PRODUCT CHANGE NOTICE

**Data Sheet Specification and
Design Change for Intersil
Product ZL9101MIRZ***

**Refer to:
PCN11118**

Date: November 16, 2011

The data sheet electrical table limits and range changes are as follows:

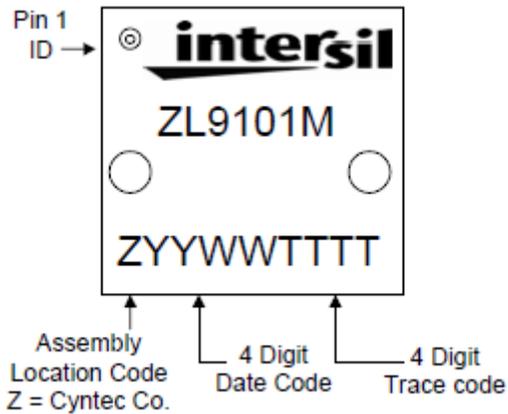
Recommended Operation Conditions	Current Range	New Range
Output Voltage Range, VOUT	0.54V to 4V	0.54V to 3.6V
Output Current Range, IOU	0A to 15A	0A to 12A

Electrical Specifications - Parameter	Current Limit			New Limit			Unit
	Min	Typ	Max	Min	Typ	Max	
Input Bias Shutdown Current, IDDS	-	9.5	12	-	15.5	20	mA
Input Supply Current, IVIN	-	1.5	2	-	1.32	-	A
Driver Supply Current	-	190	220	-	190	250	uA
Output Load Current	Parameter Added			-	12	-	A
Switching Frequency Range	590	615	630	500	571	1000	kHz

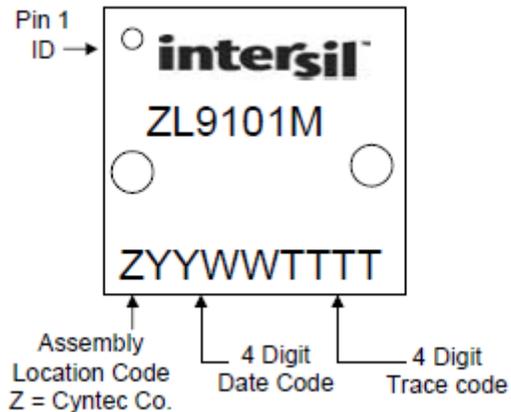
There will be no change in the part number marked on the packaged parts. Product manufactured with the improved design will begin with date code **1131** and use the new Intersil logo. Examples of the current and new branding/marketing layouts are included below.
